RAI Volume 3, Chapter 2.2.1.3.4, First Set, Number 2, Supplemental Question:

RAI Volume 3, Chapter 2.2.1.3.4, First Set, Number 8, Supplemental Question 1:

RAI Volume 3, Chapter 2.2.1.3.4, Second Set, Number 3, Supplemental Question:

Figure 1. Scatterplot of pH in the Waste Form Domain (cell 1) and the Corrosion Product Domain (cell 2) for Commercial SNF Waste Packages in Percolation Bin 3 at 1,000 Years and 10,000 Years Postclosure after an Igneous Intrusion at 250 Years

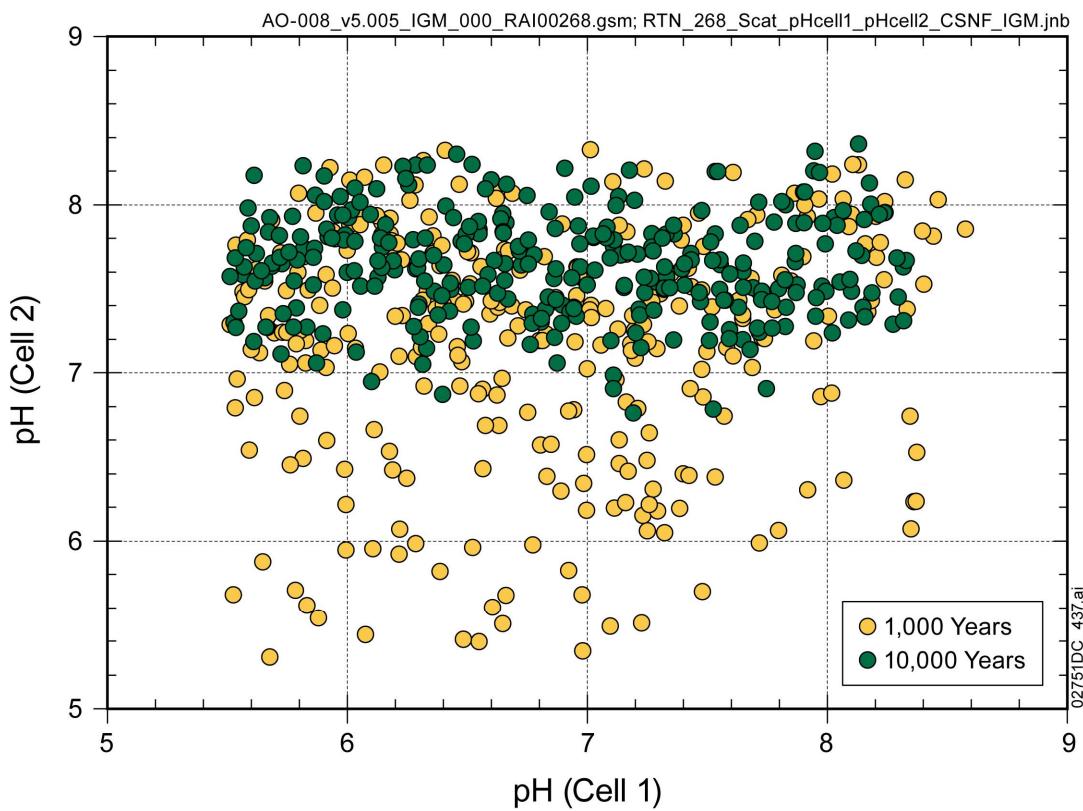
Page 2 of that response states that a “strong correlation exists between the models for pH and [the waste form and corrosion products] domain.” Does this statement refer to a mathematical correlation or is it simply a statement that there is a relationship because they both rely, in part, on CO₂ partial pressure? Also, please direct NRC staff to discussions of model support for the corrosion products pH abstraction.

The referenced statement is not meant to imply a direct statistical correlation embedded in the models, but simply that the pHs in the two domains are related through their dependence on CO₂ partial pressure. However, the observable relationship or correlation is relatively weak, as indicated in a scatterplot comparing the pH values in the two domains (Figure 1).

Figure 1. Fraction of Realizations with Breached (a) Codisposal Waste Packages and (b) Commercial SNF Waste Packages that have Stable Colloid Suspensions, in Percolation Subregion 3, Drip Environment, for an Epistemic Sample of Size 300 for the Nominal Modeling Case for 1,000,000 Years

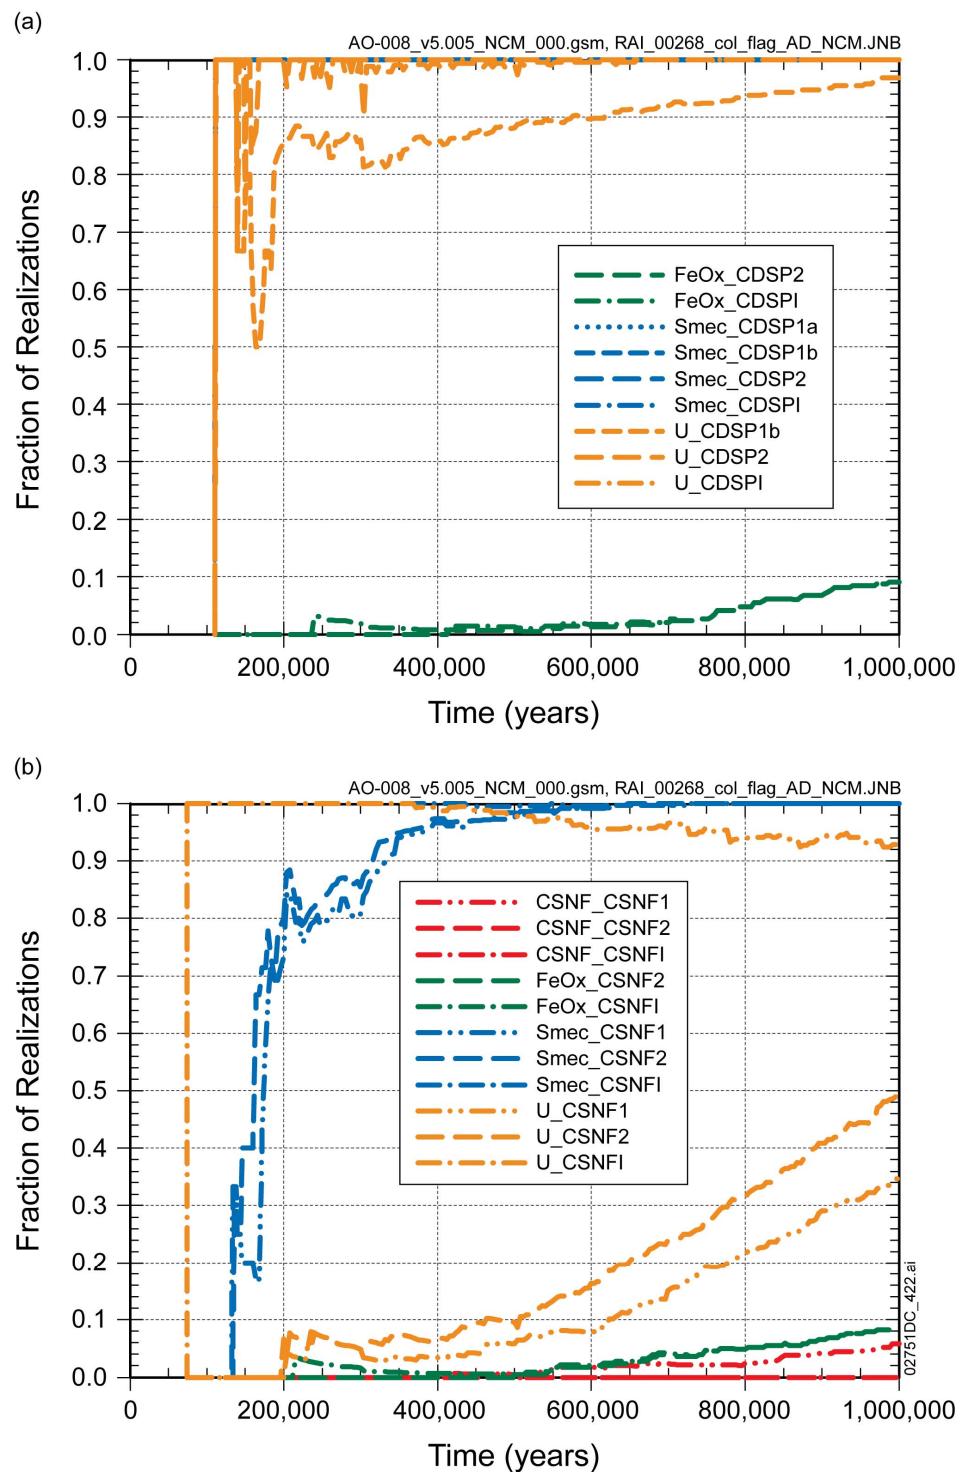
Clarify why disruptive modeling cases (high dose) are chosen over the nominal case (lower dose) for elaborating processes that limit colloid release and transport in the EBS. Clarify which processes controlling the aqueous chemical characteristics governing colloid stability discussed for the disruptive cases are also applicable to the nominal case and whether iron oxide and/or SNF colloids are typically unstable in the corrosion products domain also for the nominal case.

The nominal modeling case is most like the seismic ground motion modeling case, because both cases have nominal general corrosion rates of the waste packages which result in no water flow through the package until corrosion patches open. This is one of the reasons why colloid suspension stability plots 27 through 30 were provided for the seismic ground motion modeling case in the response to this RAI at both 300,000 years (which is before patch failures which are due to nominal processes) and at 1,000,000 years (which is subsequent to patch failures).

Like the seismic ground motion modeling case, in the nominal modeling case commercial spent nuclear fuel (SNF) colloid suspensions are unstable in the corrosion products domain, and only those realizations with advective flow have stable FeO_x colloid suspensions in the corrosion products domain. Thus, the green and red lines in Figure 1 of this supplemental response (nominal) are similar to those in Figure 15 of the initial response to this RAI (seismic). (see Section 1.3 of the initial response to this RAI for an explanation of the figure legends.)

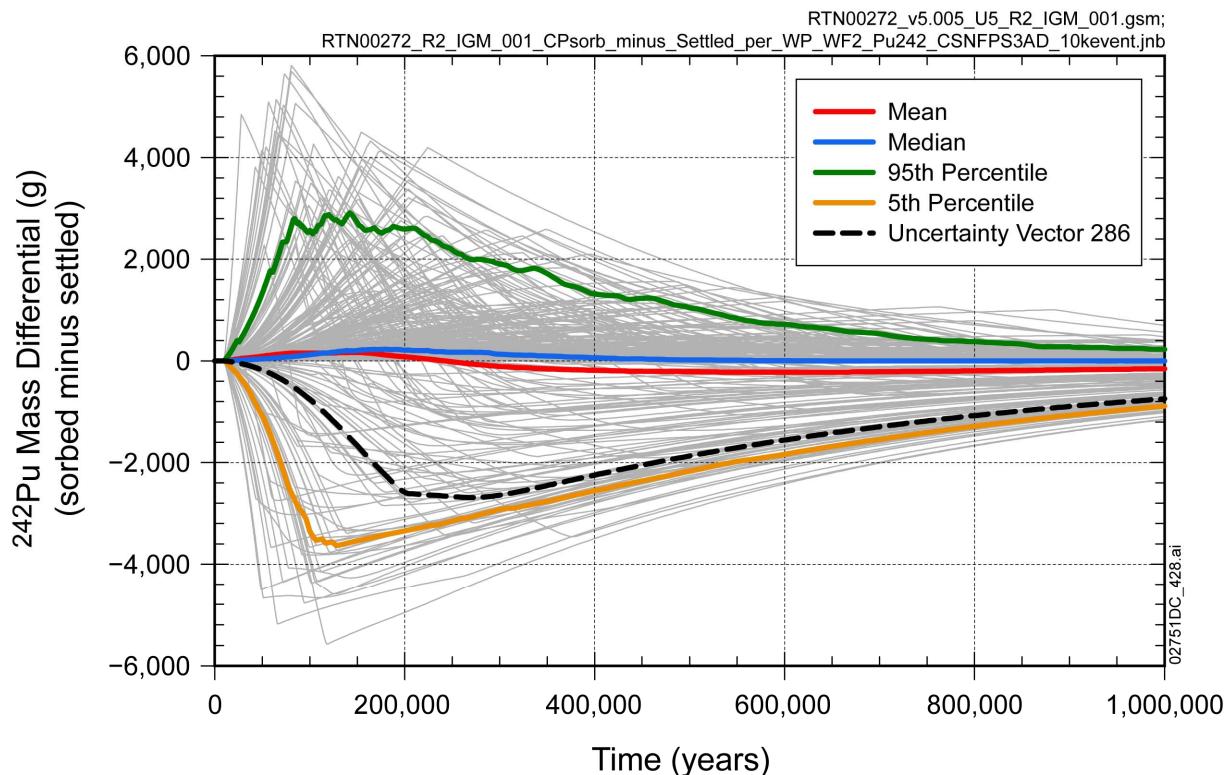
In the response to RAI 3.2.2.1.3.4-2-007, Figure 1.1-26 shows that, for realization 2855, the vast majority of ^{242}Pu mass in the corrosion products domain is associated with settled CSNF waste form colloids. Clarify whether the result from this realization is representative of the plutonium behavior in the corrosion products domain.

Because of the threshold behavior of colloid stability in the chemical environment of the waste package and the associated uncertainty in the relevant environmental parameters, a wide range of behavior is observed in the plutonium budget from commercial SNF waste forms in the corrosion products domain. The range is defined by two extremes: (1) realizations similar to 2855, in which a significant mass of plutonium is released as irreversibly attached to waste form colloids from the waste form domain, and then flocculates (settles) in the corrosion products domain, and (2) realizations where waste form colloids are unstable in the waste form domain, in which plutonium is released mainly in the dissolved state from the waste form domain, and then sorbs onto stationary corrosion products. The comparison between plutonium mass sorbed onto stationary corrosion products and mass irreversibly attached to settled waste form colloids is illustrated in Figure 1, which shows the difference between these quantities for all 300 epistemic sample elements.

Figure 1 shows that the plutonium mass difference in realization 2855 (epistemic uncertainty vector 286) is similar to the 5th percentile plutonium mass difference for the set of 300 epistemic uncertainty vectors, indicating that realization 2855 is near one extreme of the outcomes. However, as indicated by the mean (red) curve in Figure 1, the mean of the differences is approximately zero over the entire simulation time of 1,000,000 years. This indicates that, on average over the entire range of epistemic uncertainty, the plutonium mass settled as waste form colloids is approximately equal to the plutonium mass sorbed onto stationary corrosion products.
